Conneaut Planning Commission MEETING AGENDA July 2, 2019- 6:00 P.M.

Re: *O'Reilly Auto Parts Roadway Sign Submittal*
SimonCRE Carp III, LLC
Buffalo Street Between Monroe Street and State Street

**Re: Conneaut Travel Center (Truck World) Site Improvement Plans
Sowards Engineering Consultants, LLC**

November, 2016
C-150-Windload Rating
5.15-SignCabinet-PE-DF
75.00 sq.ft.

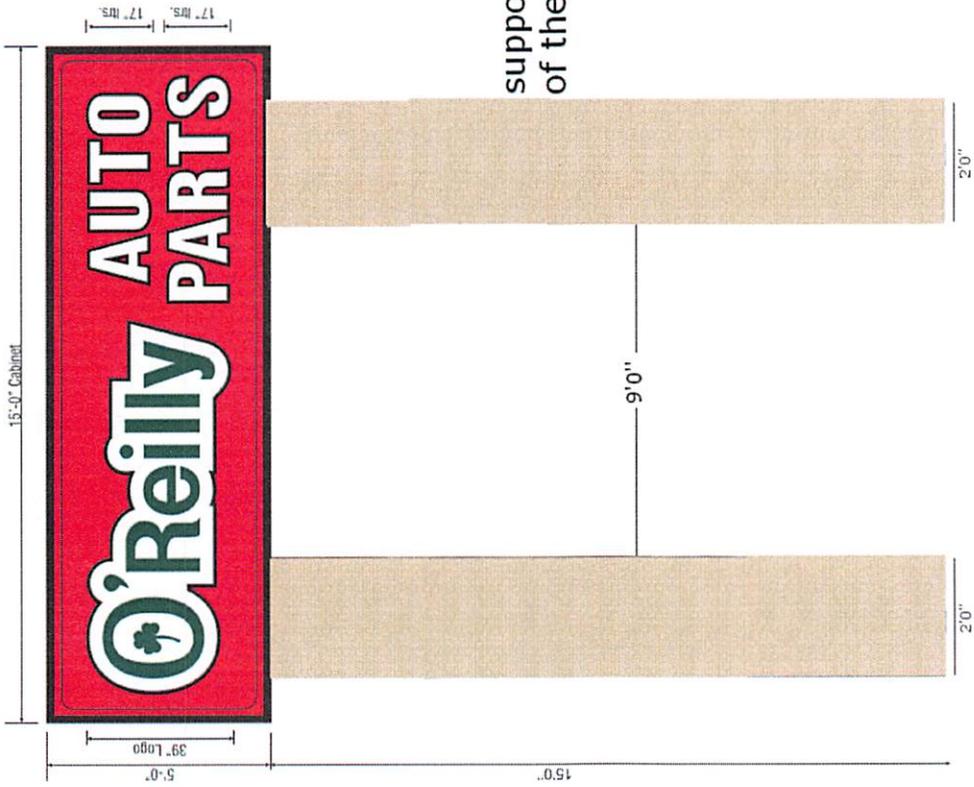
We have reviewed the subject drawings received on June 25, 2019 and recommend them for approval. With the open and decorative concept, no sight distance issues are anticipated.

| SHEET NO. | C-8 |

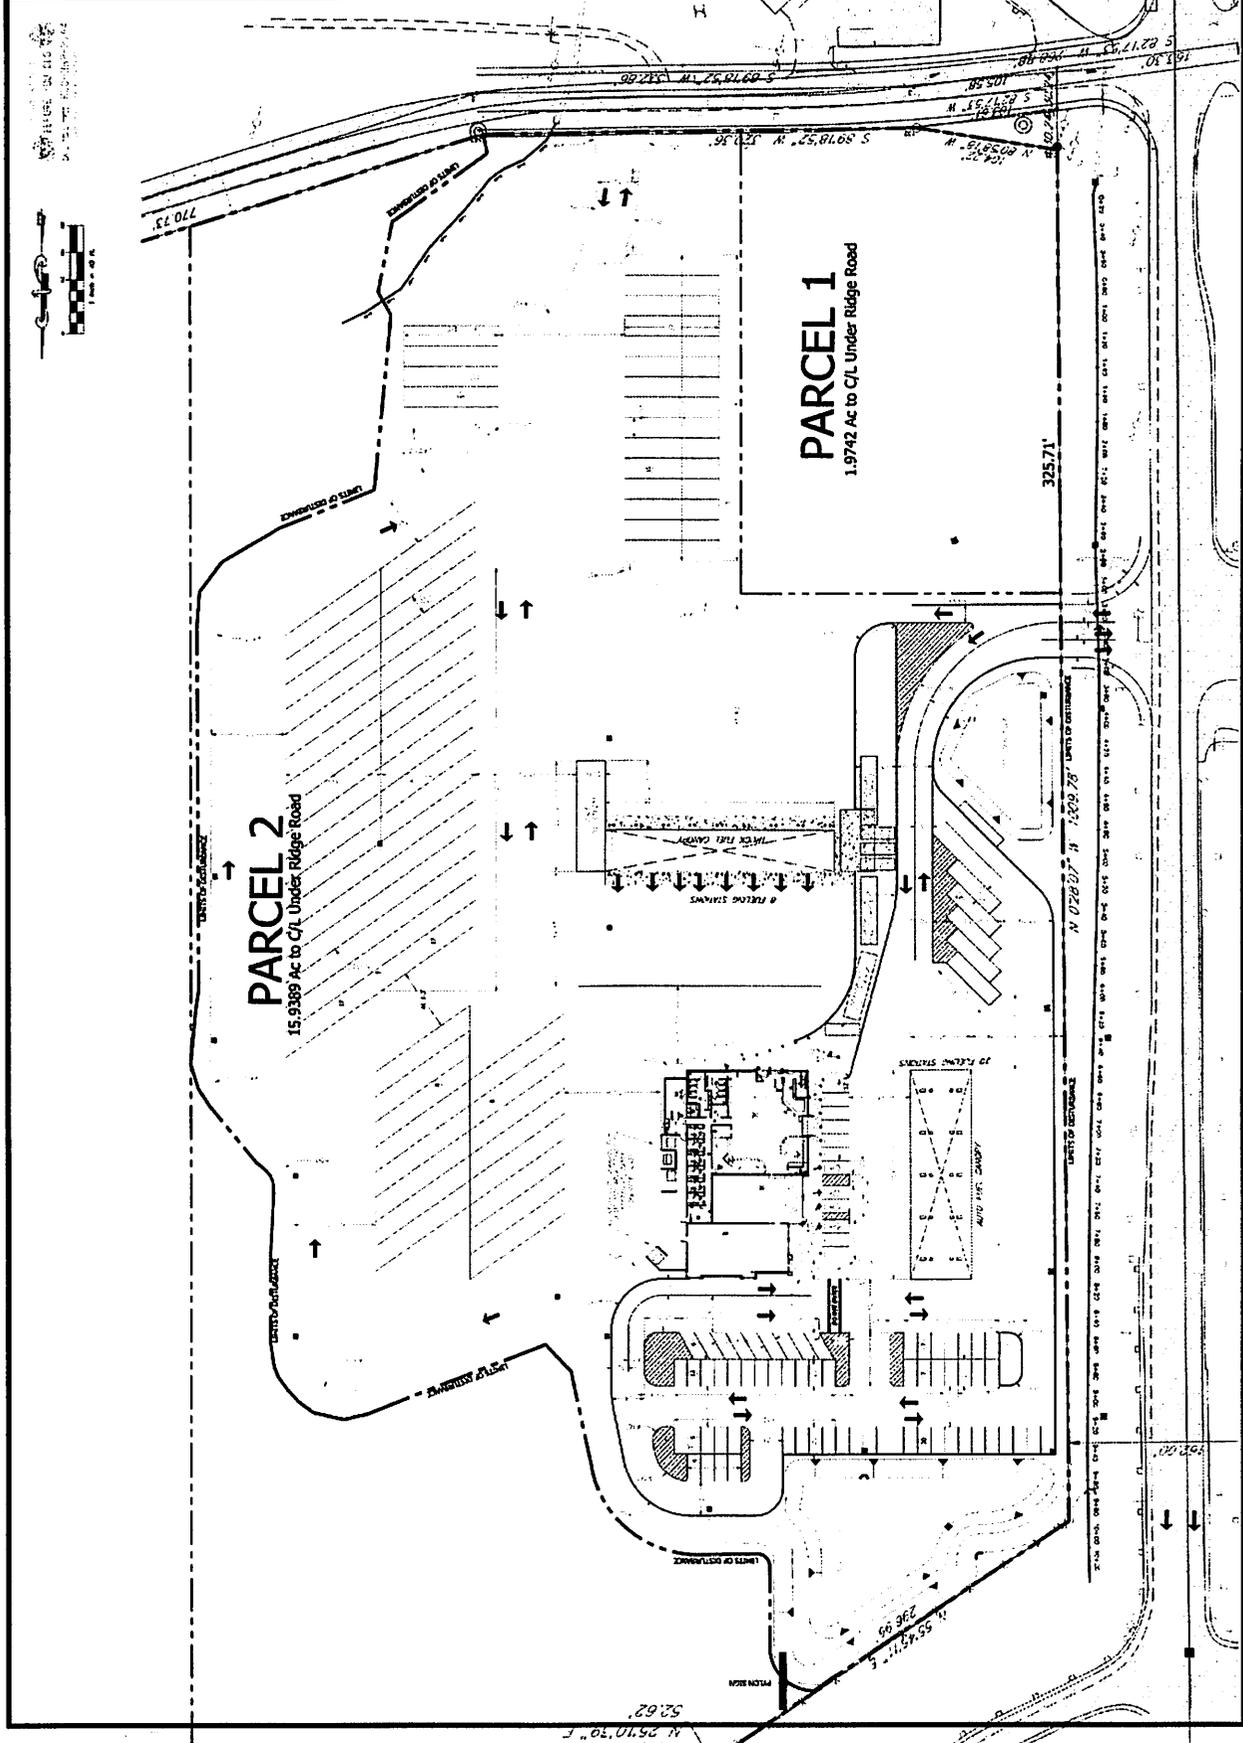
- **Permitted Uses and Minimum Lot Size:** All of the proposed principal uses are permitted by right in the B-1 District (1121.01). The site plan (Sheet C-8) indicates a lot split to create a parcel for a future hotel (Parcel 1, 1.972 ac to C/L of Under Ridge Rd). However, hotels require a minimum lot size of 2 acres, which for the purposes of zoning is the area of the lot located outside the public right-of-way. This means that when development on Parcel 1 is proposed in the future, a *hotel will require an area variance*. (see 1103.01)

- **Front Building and Parking Setback:** The minimum front setback is 50 feet, measured from the ROW line (1121.01). This setback applies to the parking lot as well as the building (1134.04(g)). The site plan (Sheet C-8) indicates the parking lot has a setback of 8.3 ft. The *parking lot should be redesigned to comply with the 50 ft setback*, especially when considering the Love's development across the street and its much larger pavement setback. While the applicant has the right to seek a variance to allow the parking lot to be placed closer to the right-of-way, it is our opinion that the request is excessive given the size of the site.

A total of 151 spaces are provided on the site plan (Sheet C-8): 76 parking spaces for passenger vehicles (10' x 20'), 5 spaces for campers/RV/boat trailers (12' x 40') and 70 parking spaces for trucks (15' x 70'). The code does not distinguish between parking spaces for passenger vehicles vs trucks.

- **Parking Lot Landscaping.** Islands shown on the site plan (C-8) in the interior of the auto parking lot are required to be landscaped (1134.04). The applicant should submit a landscaping plan that identifies the proposed landscaping. In addition, interior parking lot landscaping should be added to the expansive area of pavement devoted to the truck parking. (see 1135.06(s) and 1135.08(b))

A-1.0

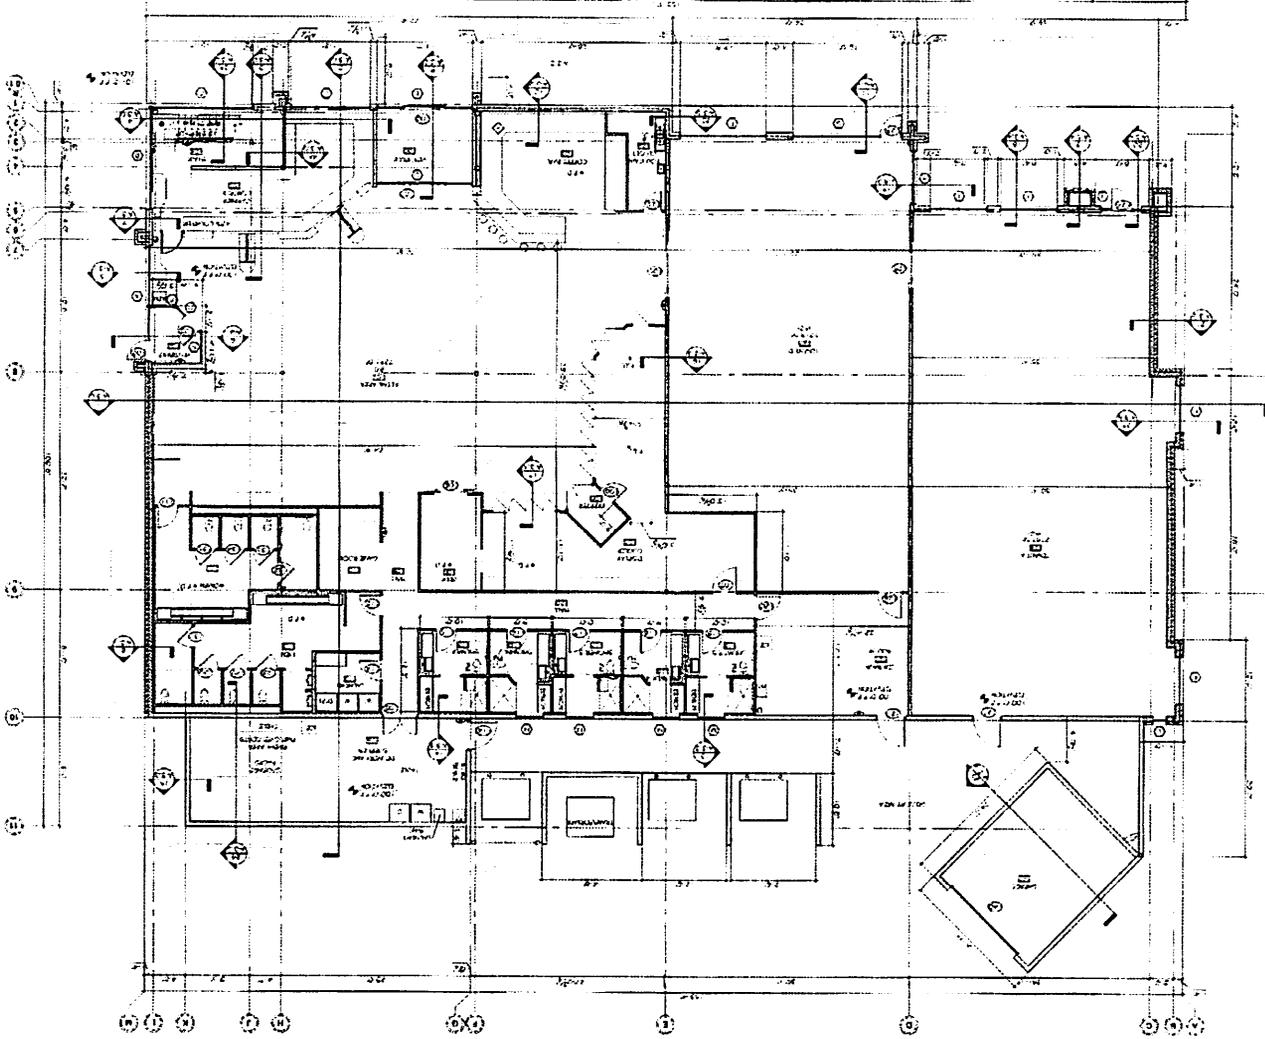
- **Required Parking Spaces:** Based on the proposed uses and associated building floor area presented by the applicant (Sheet A-1.0), Schedule 1134.05(d) requires the following number of parking spaces:
